ADDENDUM NO. 1  
Bid Due Date: 7/20/23

Description: Richmond Library Roof Systems Replacement

**ROOF SYSTEM REPLACEMENT ~~CONSTRUCTION DOCUMENT SUBMISSION~~ ISSUED FOR  
BID**  
**RICHMOND LIBRARY** **ADDENDUM 1**  
**DIGROUP ARCHITECTURE** **Issued: JULY 13, 2023**

Sheet Name:  
**EXTERIOR PHOTOS, MASONRY DETAILS AND NOTES**

PHOTO No. 1.1

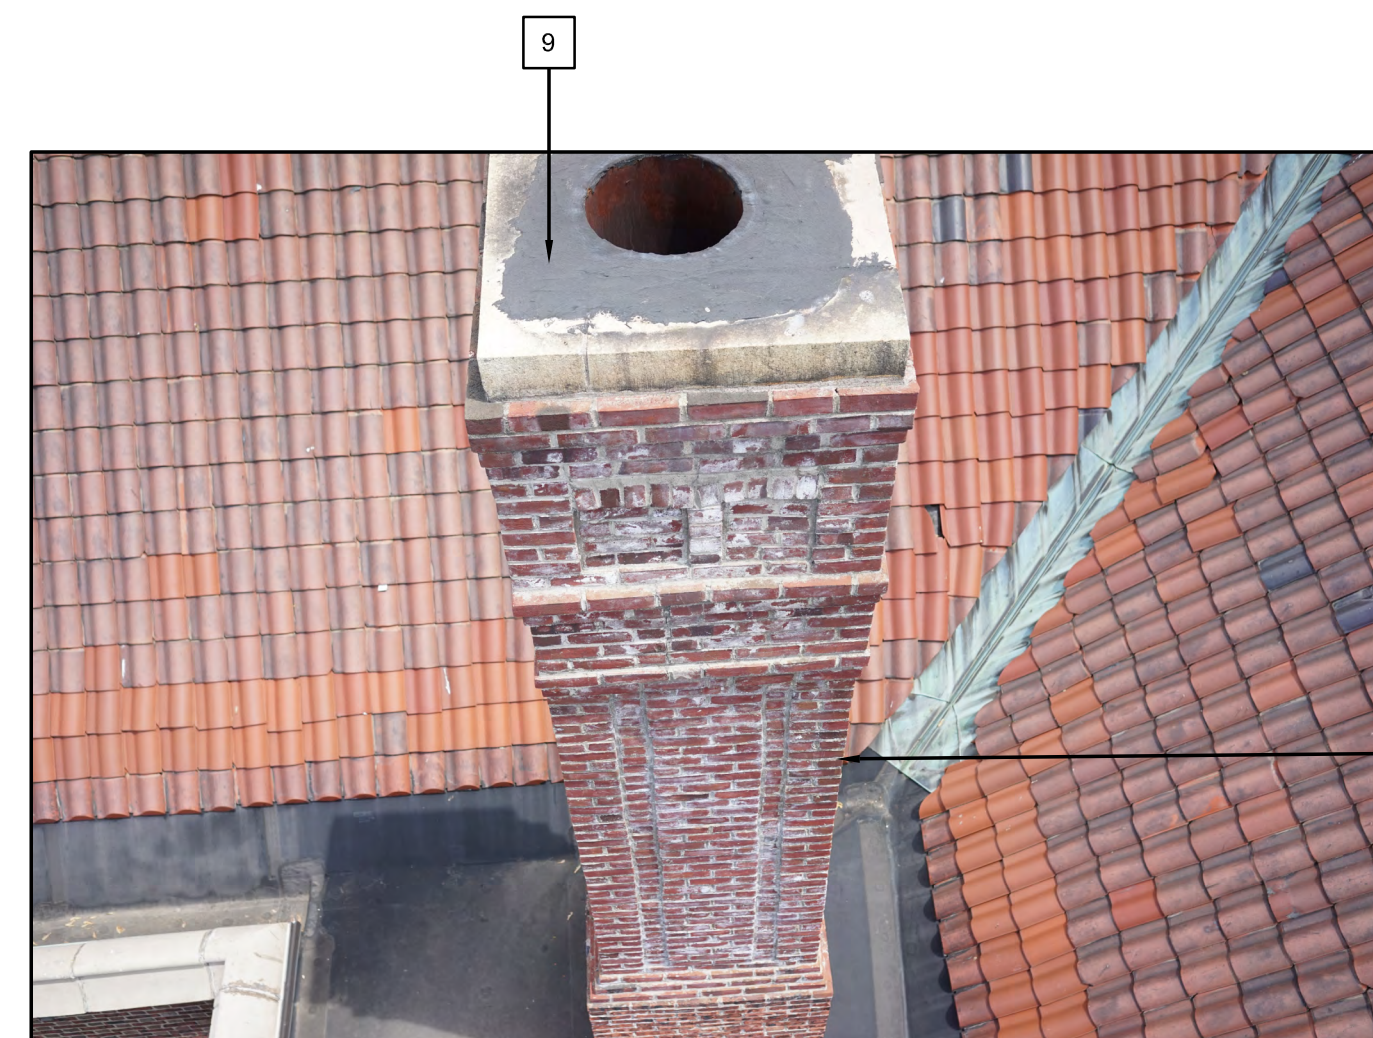
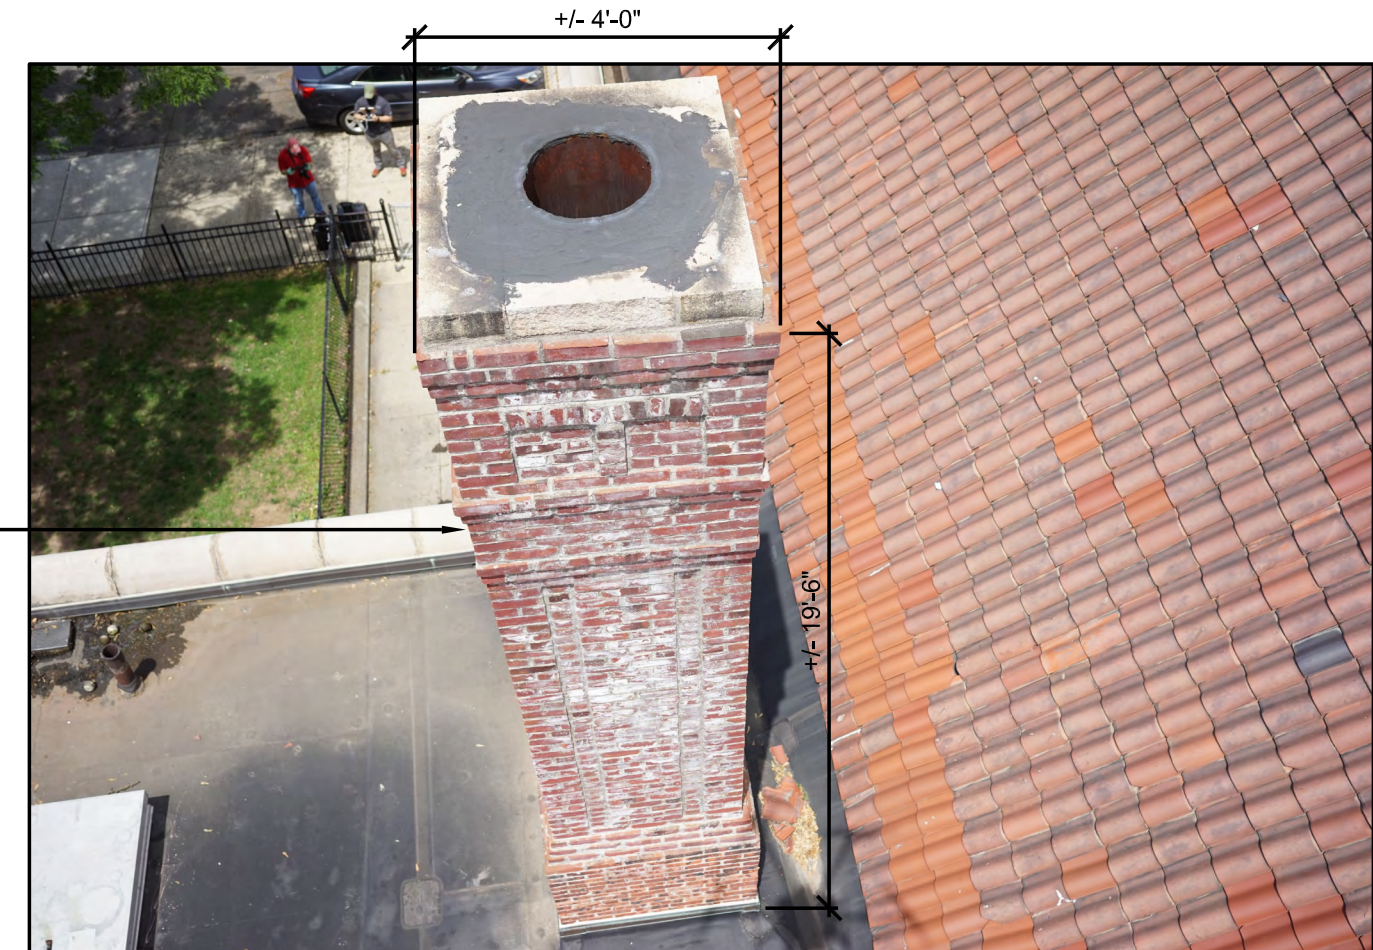
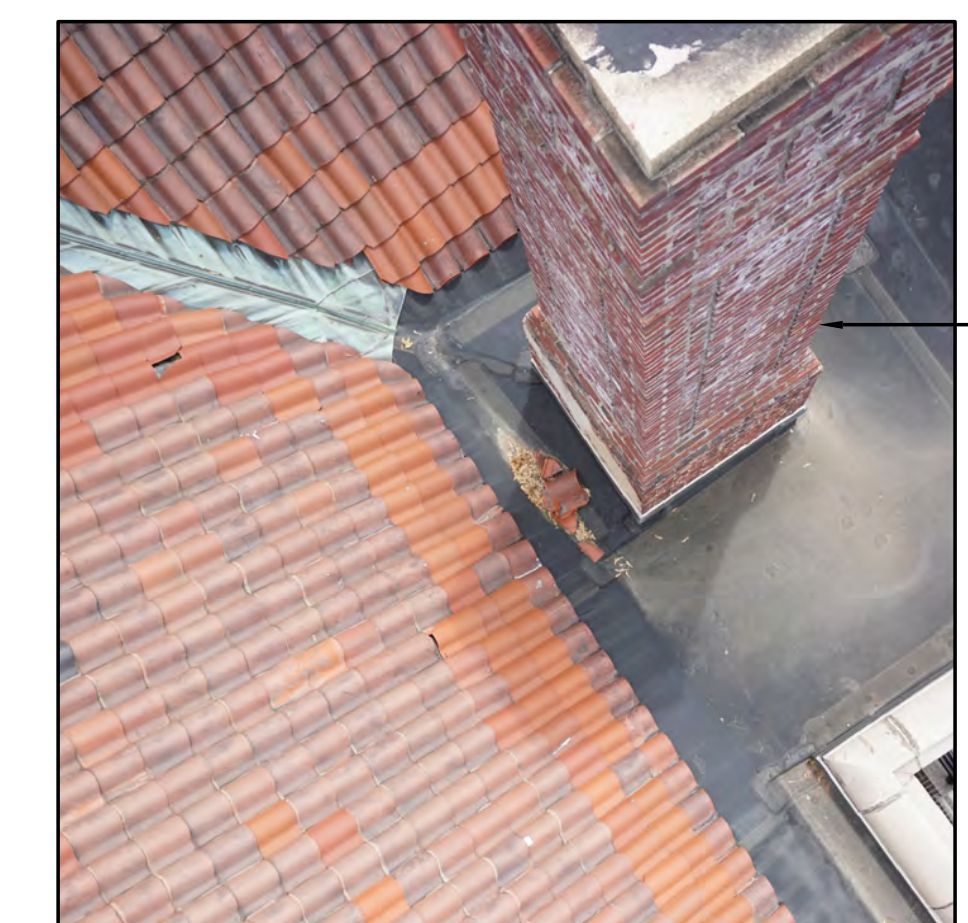
6. Remove Drawing A-103, EXTERIOR PHOTOS, MASONRY DETAILS, AND NOTES and Replace with attached Drawing A-103, EXTERIOR PHOTOS, MASONRY DETAILS, AND NOTES and.

- 1 BASE BID: RAKE AND REPOINT BRICK MASONRY OF CHIMNEY IN ITS ENTIRETY. (ALL FOUR SIDES) SEE DETAILS 3/A-103 AND 4/A-103 FOR ADDITIONAL INFORMATION.
- 2 ALTERNATE BID #2: RAKE AND REPOINT 100% BRICK MASONRY. SEE DETAILS 3/A-103 AND 4/A-103 FOR ADDITIONAL INFORMATION.

- 3 ALTERNATE BID #1: RAKE AND REPOINT ALL TERRA COTTA BAND JOINTS INCLUDING CONTINUOUS TOP AND BOTTOM JOINTS. SEE DETAILS 3/A-103 AND 4/A-103 FOR ADDITIONAL INFORMATION.

- 4 ALTERNATE BID #1: RAKE AND REPOINT ALL TERRA COTTA WINDOW SURROUNDS INCLUDING CONTINUOUS TOP AND BOTTOM JOINTS. SEE DETAILS 3/A-103 AND 4/A-103 FOR ADDITIONAL INFORMATION. CAREFULLY REMOVE AND STORE WINDOW SECURITY GRILLS AND REINSTALL FOLLOWING THE COMPLETION OF MASONRY WORK.

- 5 ALTERNATE BID #1: RAKE AND REPOINT ALL TERRA COTTA ENTRANCE SURROUNDS. SEE DETAILS 3/A-103 AND 4/A-103 FOR ADDITIONAL INFORMATION.
- 6 ALTERNATE BID #1: RAKE AND REPOINT ALL TERRA COTTA COURNICHE INCLUDING CONTINUOUS TOP AND BOTTOM JOINTS. SEE DETAILS 3/A-103 AND 4/A-103 FOR ADDITIONAL INFORMATION.

- 7 ALTERNATE BID #1: RAKE AND REPOINT ALL TERRA COTTA ENTRANCE SURROUNDS. SEE DETAILS 3/A-103 AND 4/A-103 FOR ADDITIONAL INFORMATION. REMOVE EXISTING BIRD NETTING. INSTALL NEW BIRD NETTING TO MATCH EXISTING ONCE MASONRY WORK HAS BEEN COMPLETED.

- 8 ALTERNATE BID #1: RAKE AND REPOINT ALL TERRA COTTA AND LIME STONE ENTRANCE SURROUNDS. SEE DETAILS 3/A-103 AND 4/A-103 FOR ADDITIONAL INFORMATION.
- 9 BASE BID: CLEAN SURFACE OF MASONRY CHIMNEY CAP. RAKE AND REPOINT MASONRY JOINTS OF CHIMNEY CAP AND ROUND FLUE. PROVIDE AND INSTALL NEW +/- 17"x21" (VERIFY AND COORDINATE SIZE OF CAP WITH EXISTING CHIMNEY FLUE) 304 STAINLESS STEEL TOP MOUNTED MESH FLUE CAP.

Sheet Name:  
**EXTERIOR PHOTOS AND NOTES**

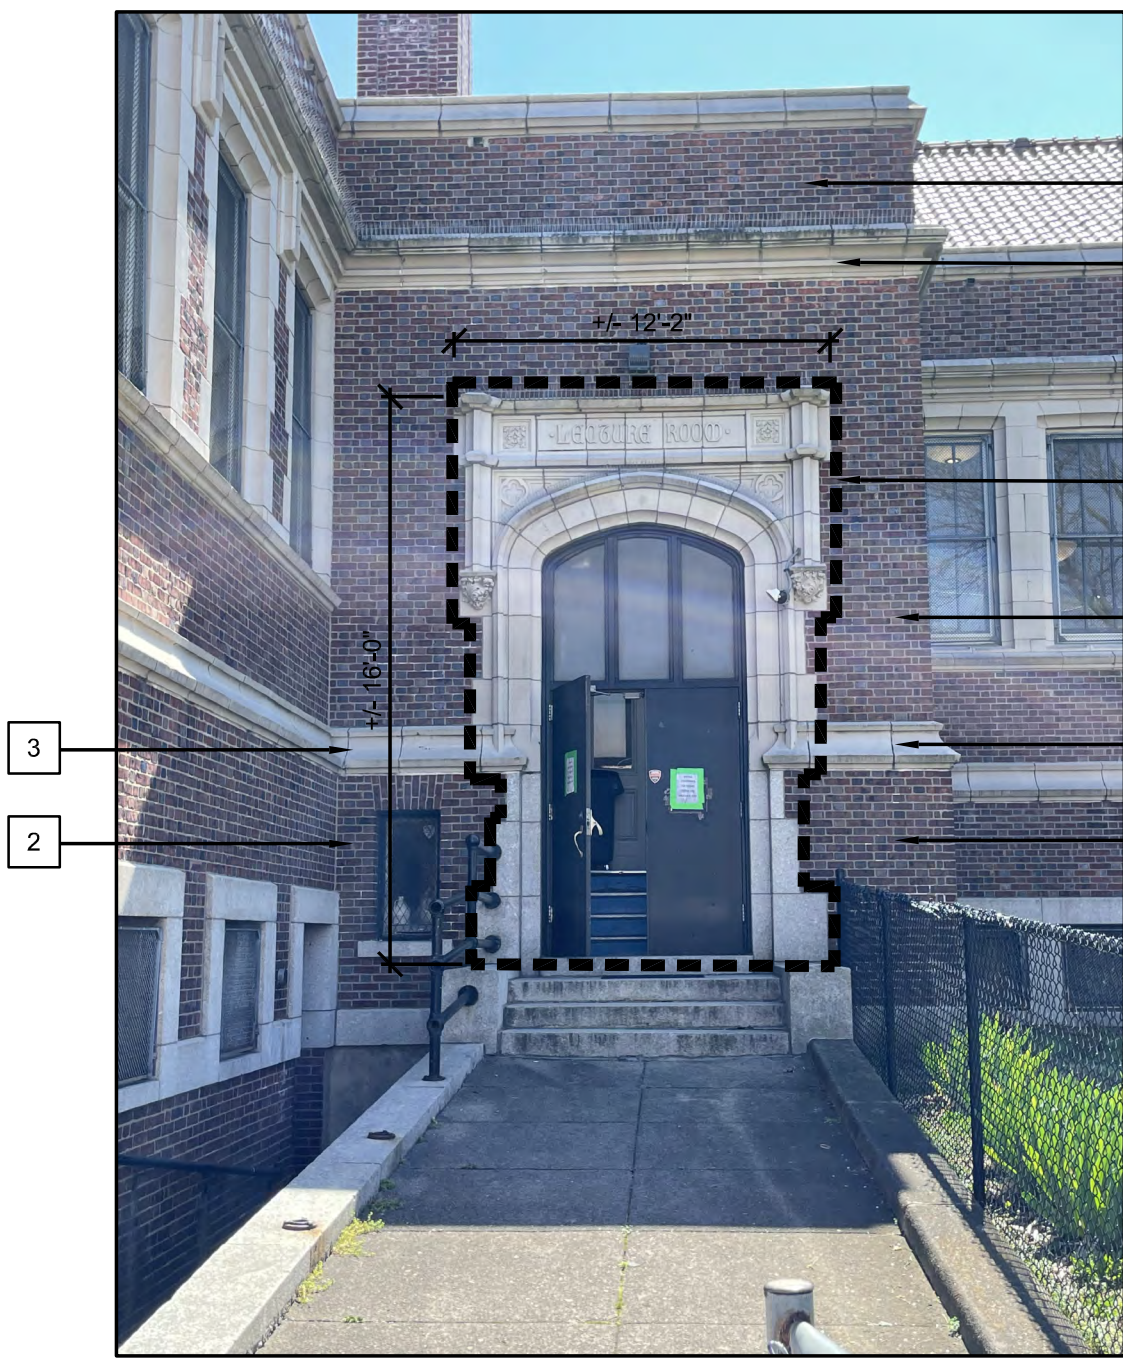
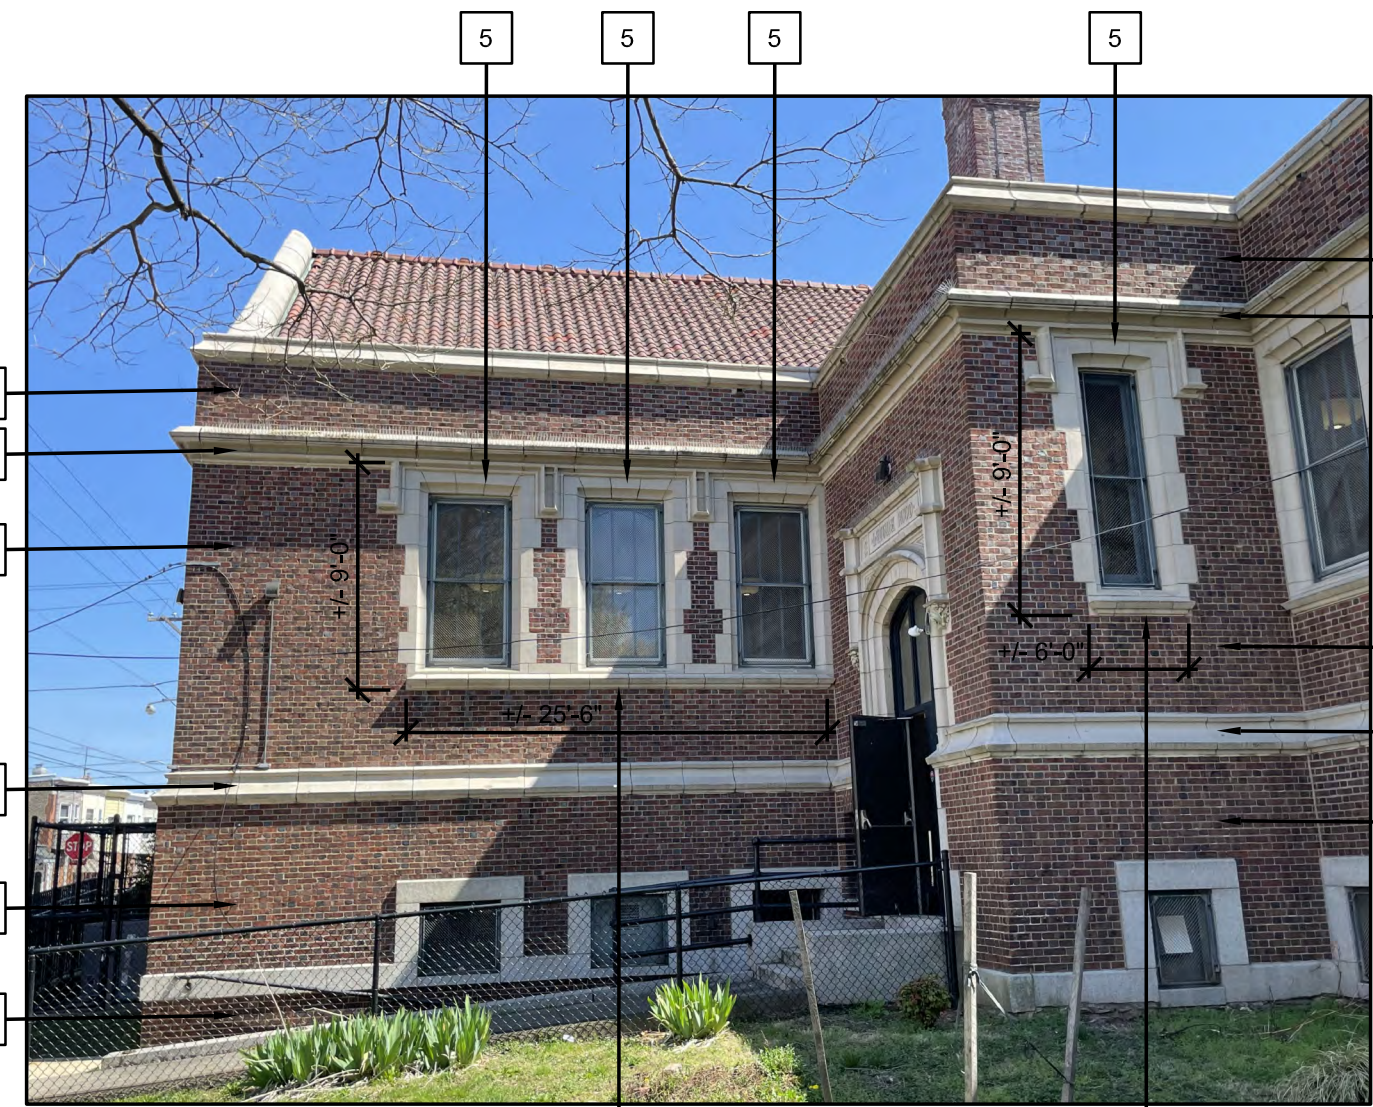
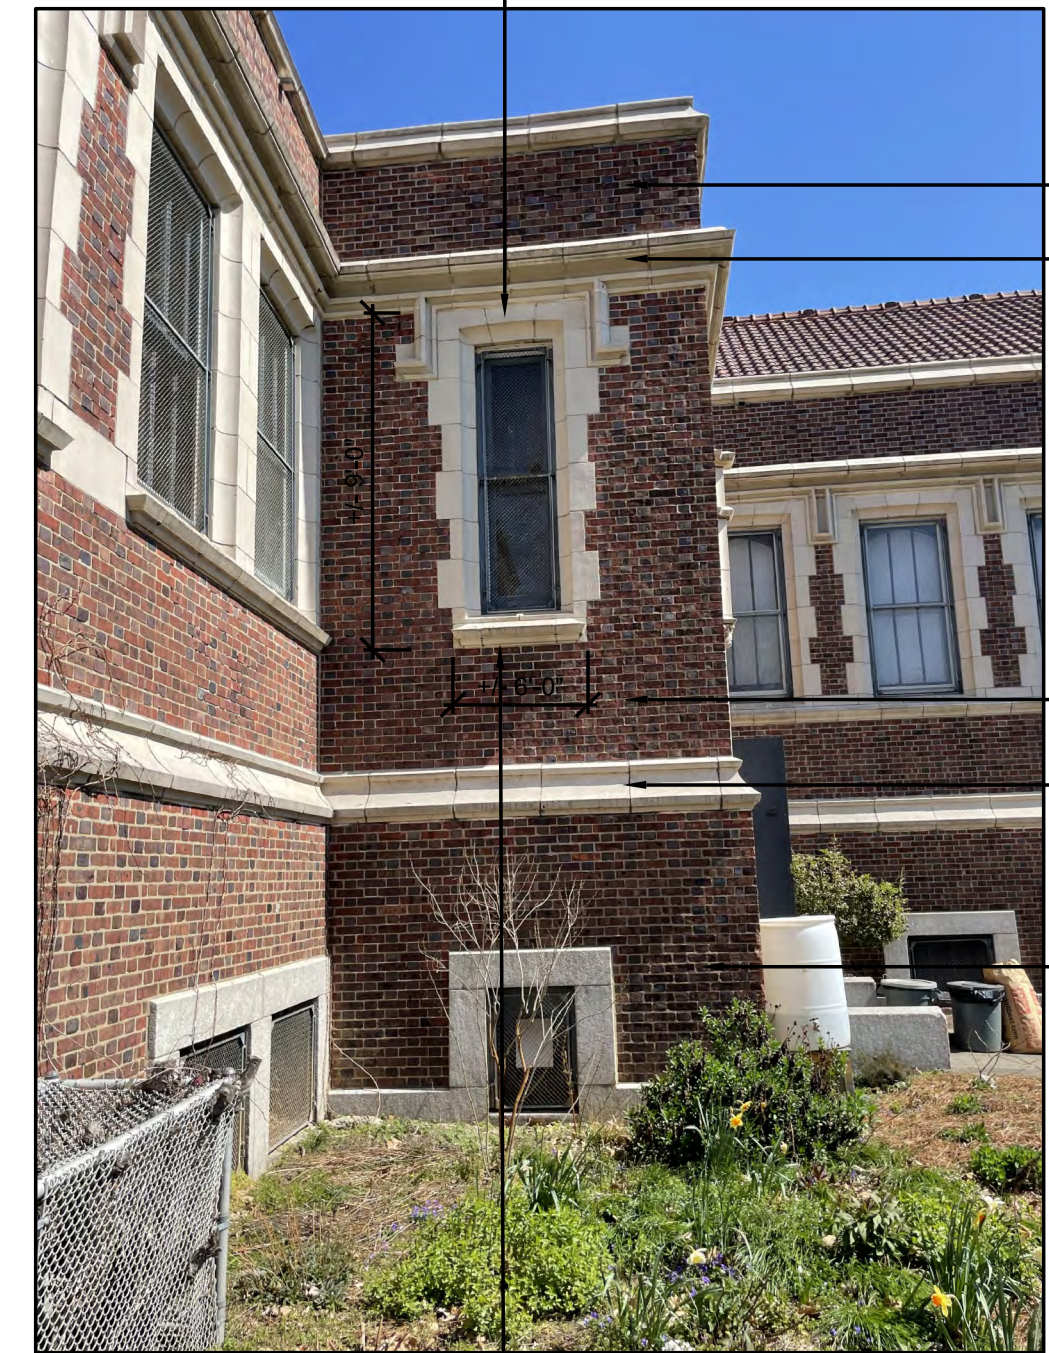
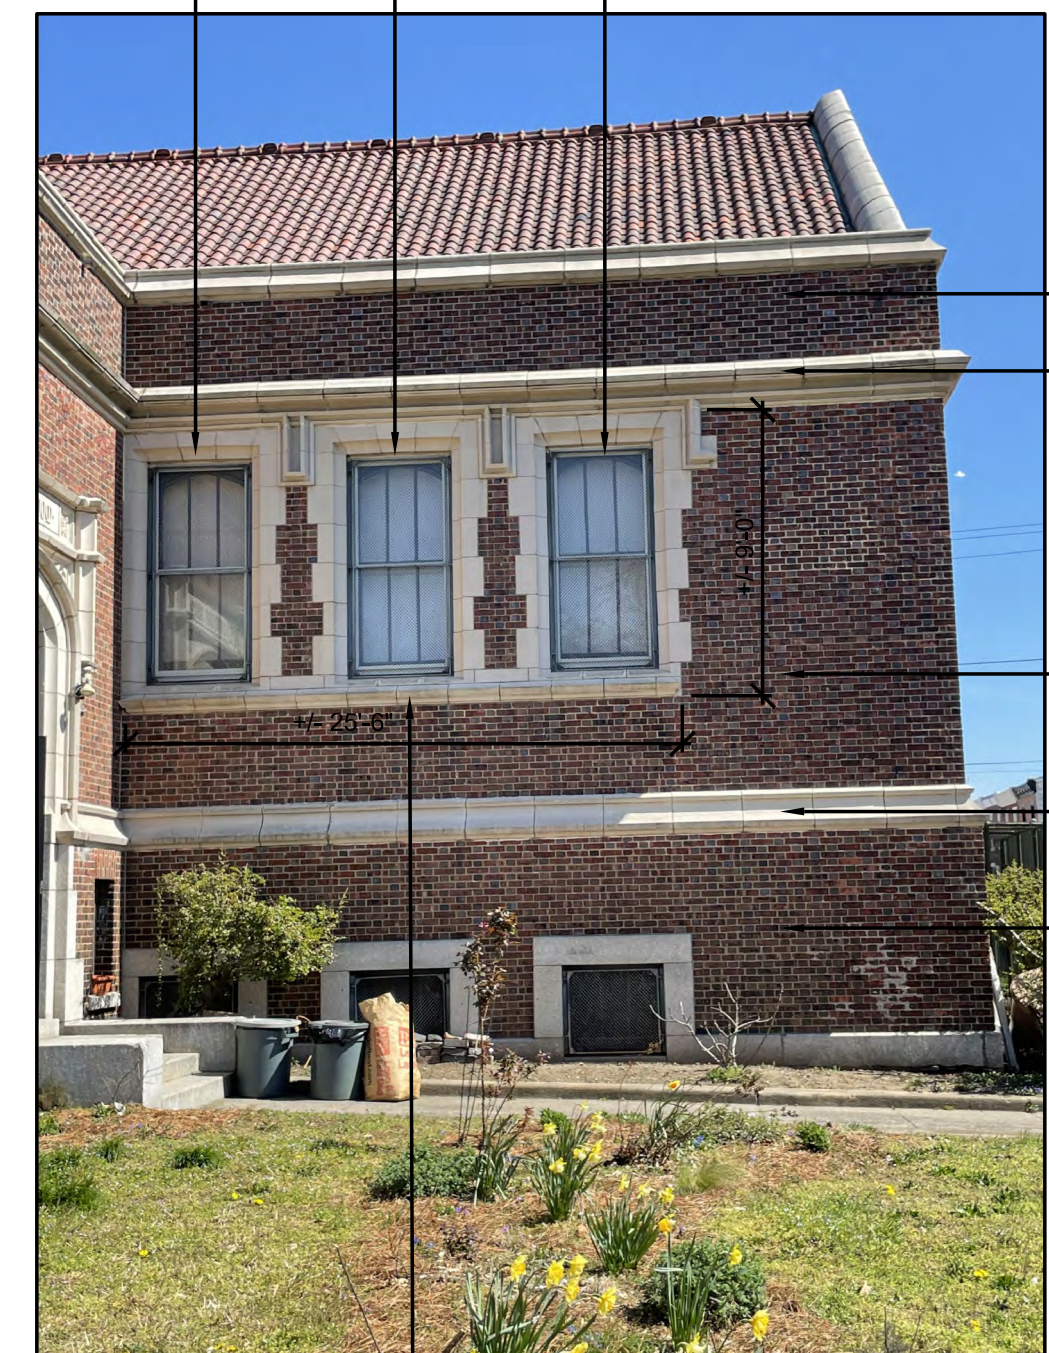
7. Remove Drawing A-104, EXTERIOR PHOTOS AND NOTES and Replace with attached Drawing A-104, EXTERIOR PHOTOS AND NOTES.

- BASE BID: RAKE AND REPOINT BRICK MASONRY OF CHIMNEY IN ITS ENTIRETY. (ALL FOUR SIDES) SEE DETAILS 3/A-103 AND 4/A-103 FOR ADDITIONAL INFORMATION.
- ALTERNATE BID #2: RAKE AND REPOINT 100% BRICK MASONRY. SEE DETAILS 3/A-103 AND 4/A-103 FOR ADDITIONAL INFORMATION.

- ALTERNATE BID #1: RAKE AND REPOINT ALL TERRA COTTA BAND JOINTS INCLUDING CONTINUOUS TOP AND BOTTOM JOINTS. SEE DETAILS 3/A-103 AND 4/A-103 FOR ADDITIONAL INFORMATION.

- ALTERNATE BID #1: RAKE AND REPOINT ALL TERRA COTTA WINDOW SILL JOINTS INCLUDING CONTINUOUS TOP AND BOTTOM JOINTS. SEE DETAILS 3/A-103 AND 4/A-103 FOR ADDITIONAL INFORMATION.

- ALTERNATE BID #1: RAKE AND REPOINT ALL TERRA COTTA WINDOW SURROUNDS INCLUDING CONTINUOUS TOP AND BOTTOM JOINTS. SEE DETAILS 3/A-103 AND 4/A-103 FOR ADDITIONAL INFORMATION.

- ALTERNATE BID #1: RAKE AND REPOINT ALL TERRA COTTA COURNICHE INCLUDING CONTINUOUS TOP AND BOTTOM JOINTS. SEE DETAILS 3/A-103 AND 4/A-103 FOR ADDITIONAL INFORMATION.

- ALTERNATE BID #1: RAKE AND REPOINT ALL TERRA COTTA ENTRANCE SURROUNDS. SEE DETAILS 3/A-103 AND 4/A-103 FOR ADDITIONAL INFORMATION. REMOVE EXISTING BIRD NETTING. INSTALL NEW BIRD NETTING TO MATCH EXISTING ONCE MASONRY WORK HAS BEEN COMPLETED.

- ALTERNATE BID #1: RAKE AND REPOINT ALL TERRA COTTA AND LIKE STONE ENTRANCE SURROUNDS. SEE DETAILS 3/A-103 AND 4/A-103 FOR ADDITIONAL INFORMATION.
- BASE BID: CLEAN SURFACE OF MASONRY CHIMNEY CAP. RAKE AND REPOINT MASONRY JOINTS OF CHIMNEY CAP AND ROUND FLUE. PROVIDE AND INSTALL NEW 1/2" X 2 1/2" (VERIFY AND COORDINATE SIZE OF CAP WITH EXISTING CHIMNEY FLUE) 304 STAINLESS STEEL TOP MOUNTED MESH FLUE CAP.
